PLANNING AND ZONING CASE CHECKLIST

P&Z CASE # SP2019-047 P&Z DATE 12/30/19 ^{PZ} CC DATE 01/14/2020 APPROVED/DENIED
ARCHITECTURAL REVIEW BOARD DATE _____ HPAB DATE _____ PARK BOARD DATE _____

Project Number: SP2019-047
Project Name: 2055 KRISTY LANE
Project Type: SITE PLAN
Applicant Name: JEFF CARROLL
Owner Name: BRAD BACON
Project Description:

SUBJECT: SP2019-047; *Site Plan for Lt 1-M, Bodin Industrial Tract*

SITE PLAN

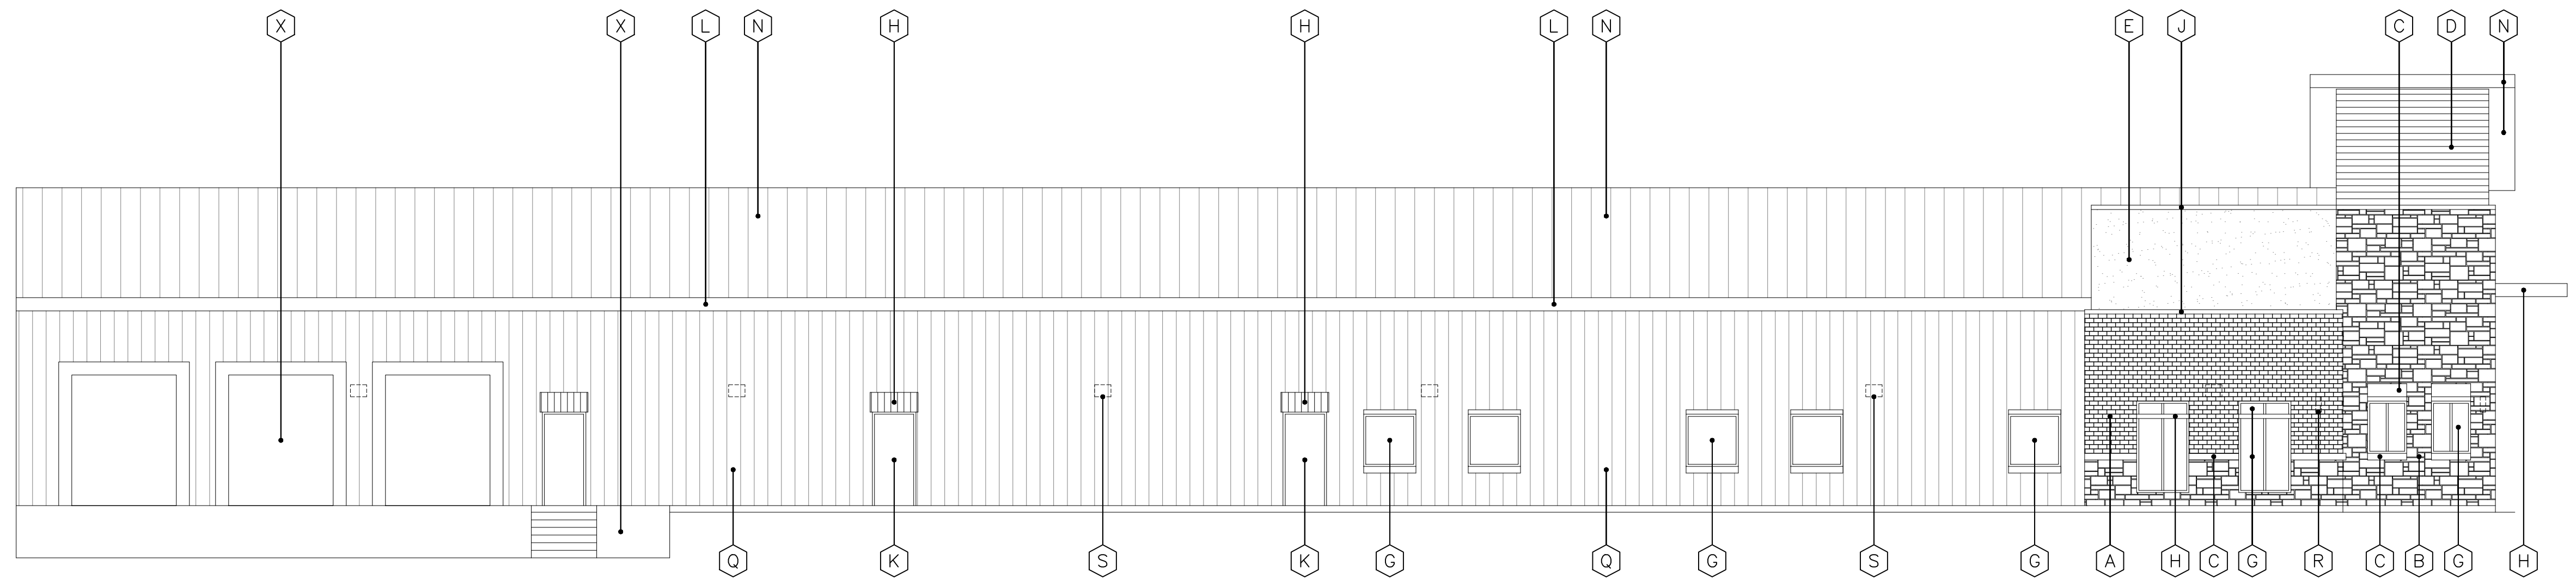
- 1) Must have detention. Size of pond is not needed for the Site Plan but you must show where the detention is going to be.
- 2) Driveway radius to be 20' minimum. May need a letter from the neighboring property to extend the driveway onto their frontage.

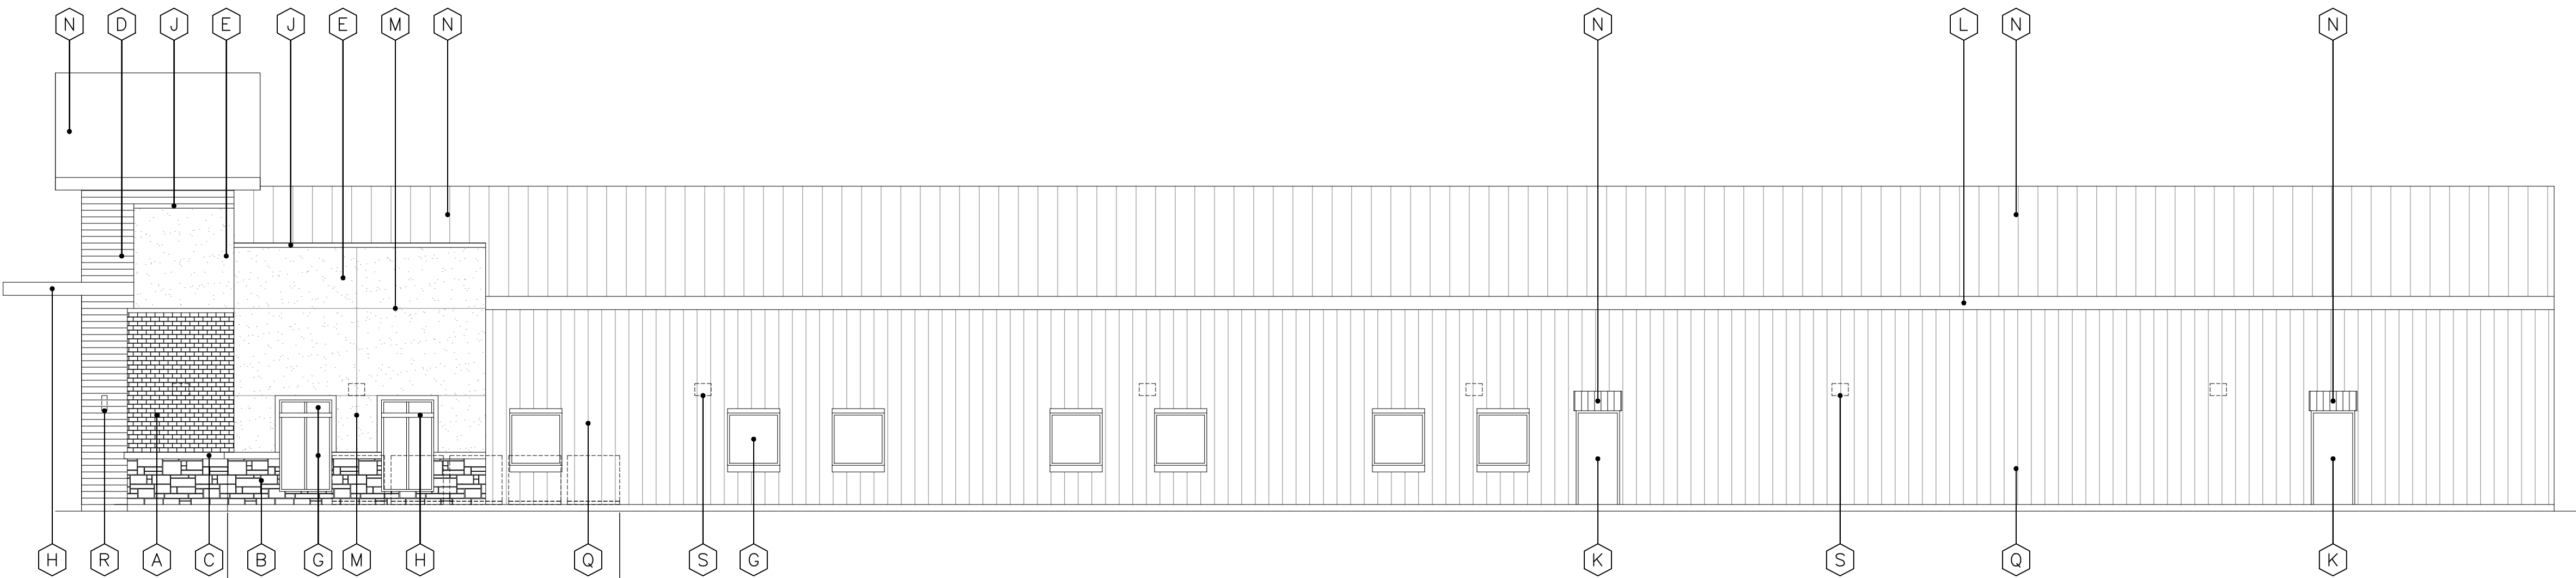
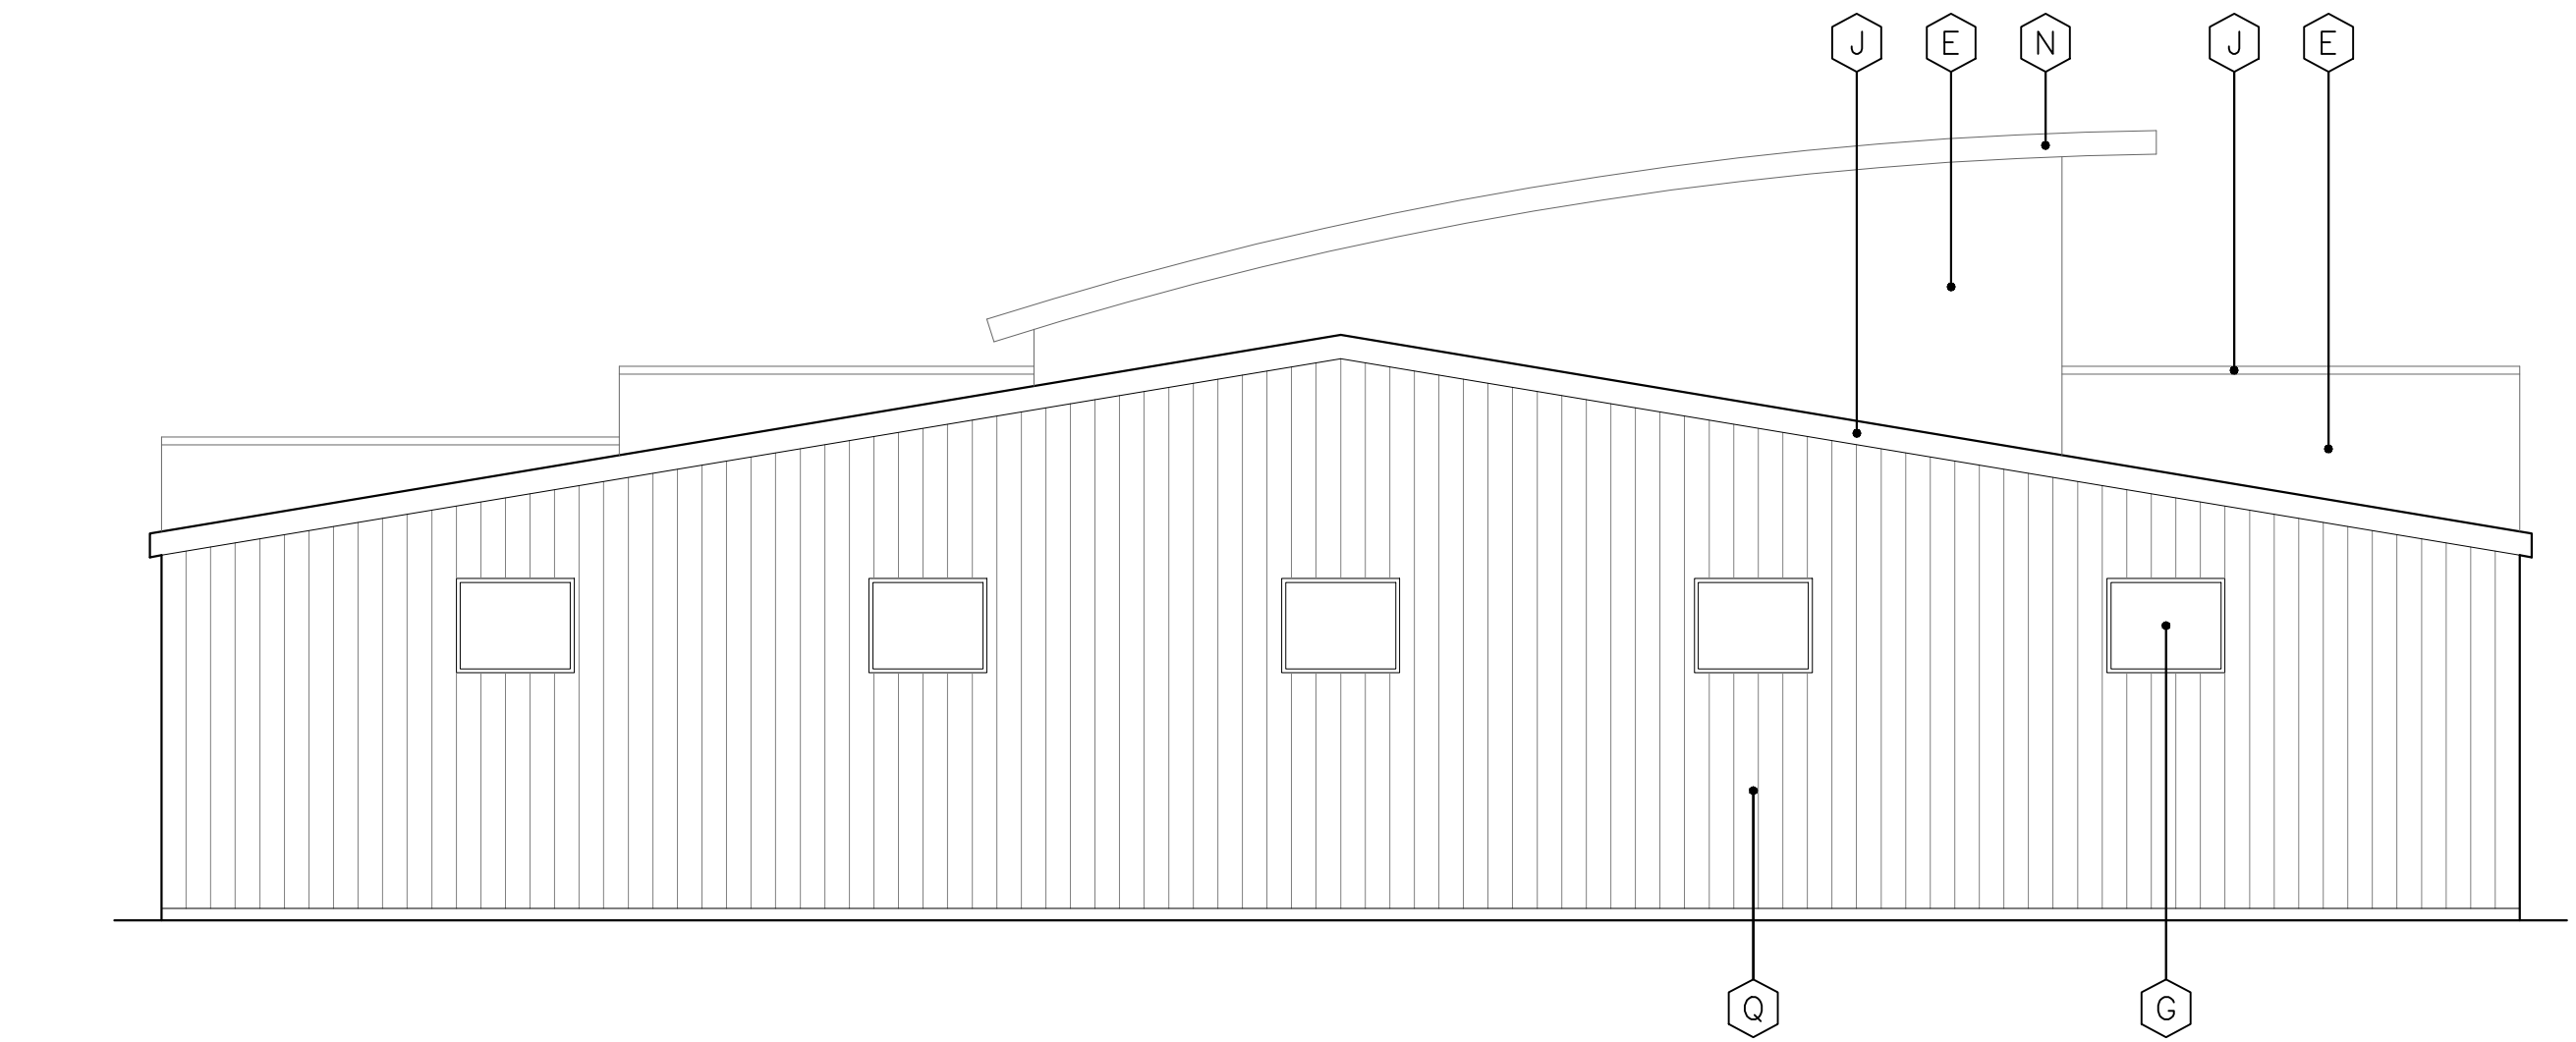
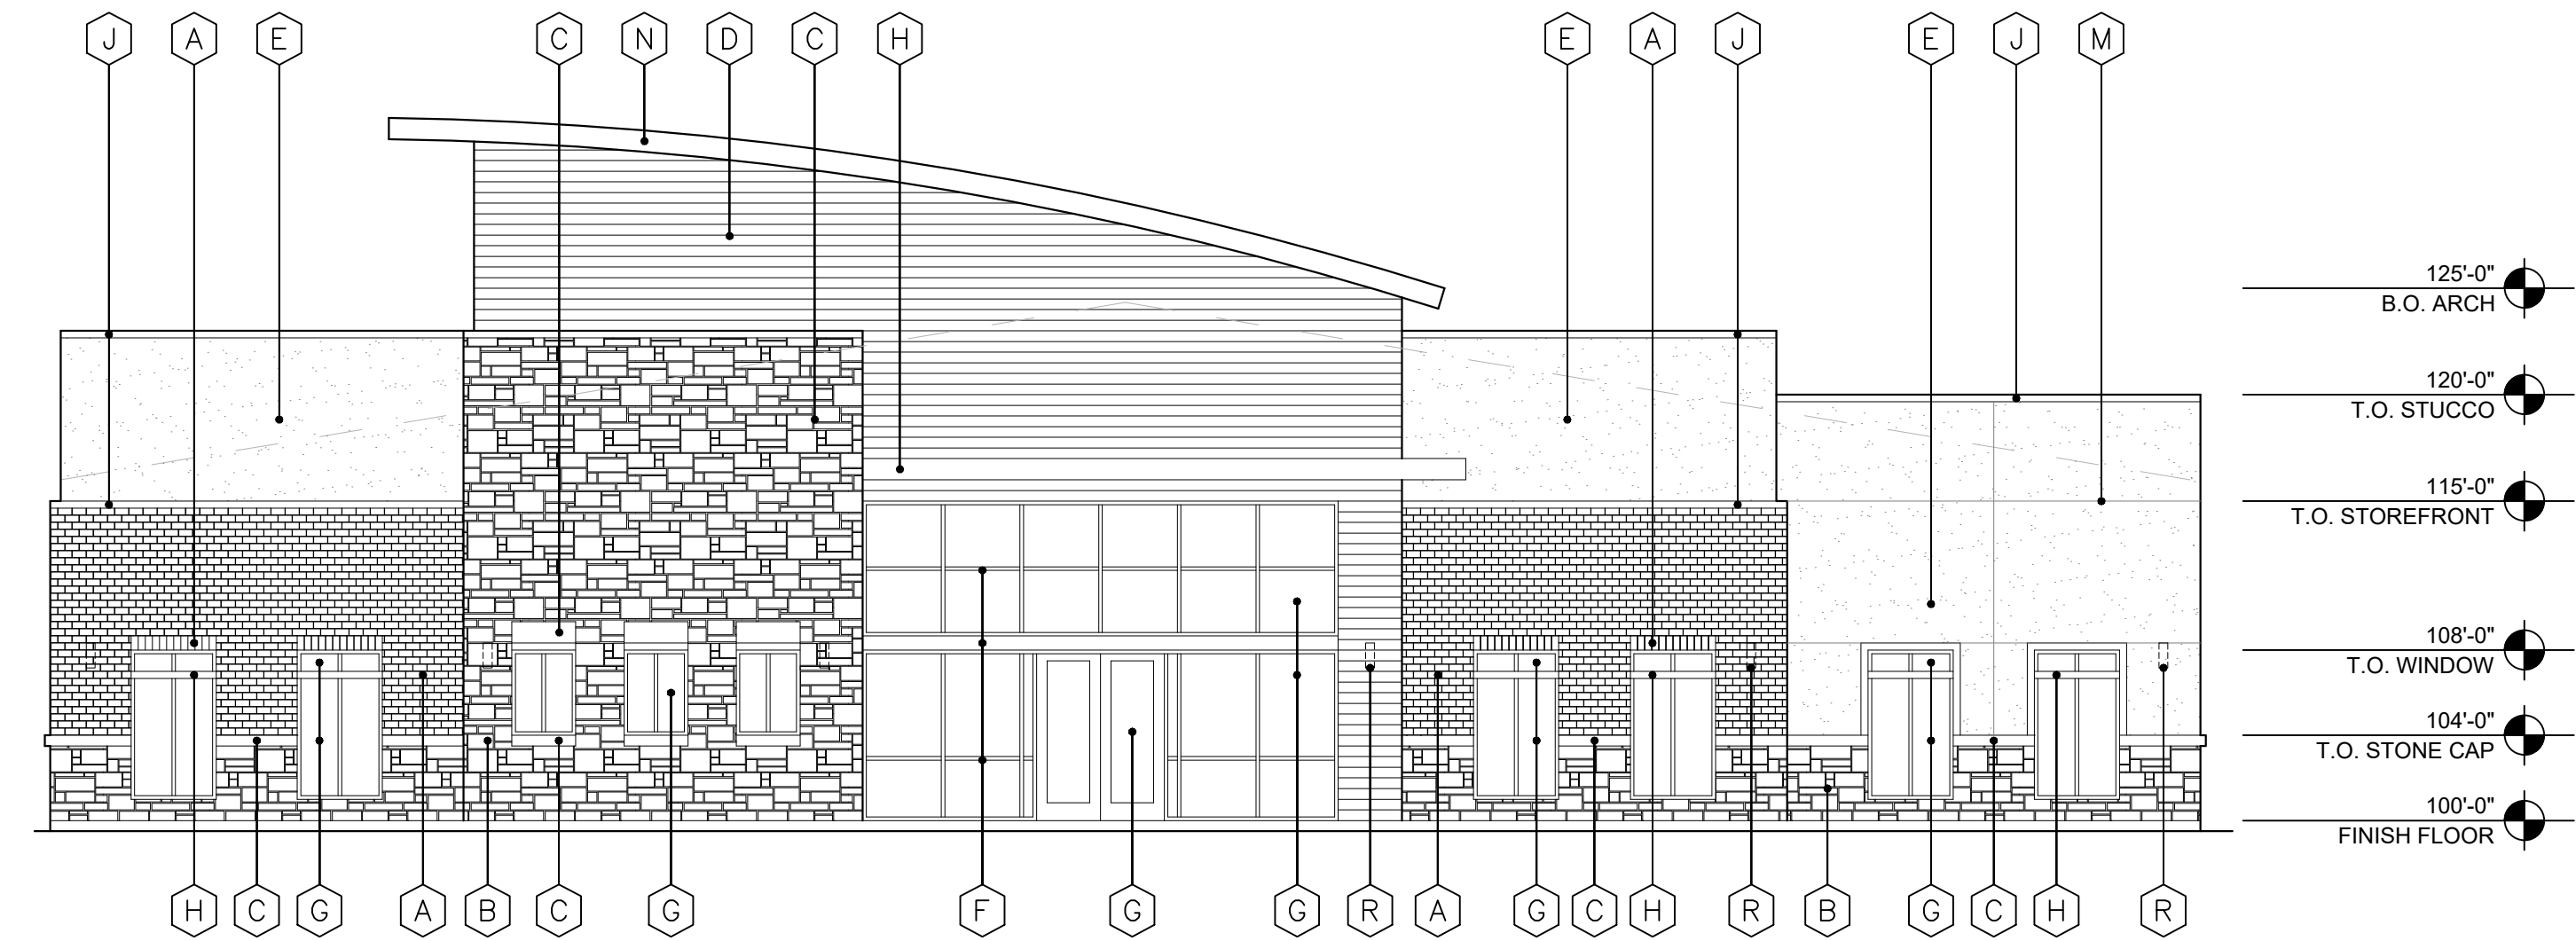
- 4) Primary Materials. The proposed building is required to have a minimum of 20% natural or quarried stone on all building façades. In this case, the applicant is proposing to use a limestone product only on the front façade. *Variance Required. ((Subsection 6.02(C)(1)(a)(1), Art. V, UDC)*

- 5) Secondary Materials. These are any material that is not deemed to be a *Primary Material* and includes materials like aluminum composite materials (ACM panels), metal panels, acrylic products (*i.e. EIFS products*) cast stone, cultured stone or other materials identified by the Director of Planning and Zoning or his/her designee. In this case the applicant is proposing to use a wood product that exceeds 10% of the materials on the front façade. *Variance Required. (Subsection 6.02(C)(b), Art. V, UDC)*

- 6) Four (4) Sided Architecture. The UDC indicates that all buildings shall be architecturally finished on all four (4) sides utilizing the same materials, detailing, articulation and features. In this case the applicant is providing architectural features, materials, and detailing only on the front façade. *Variance Required. (Subsection 6.02(C)(5), Art. V, UDC)*
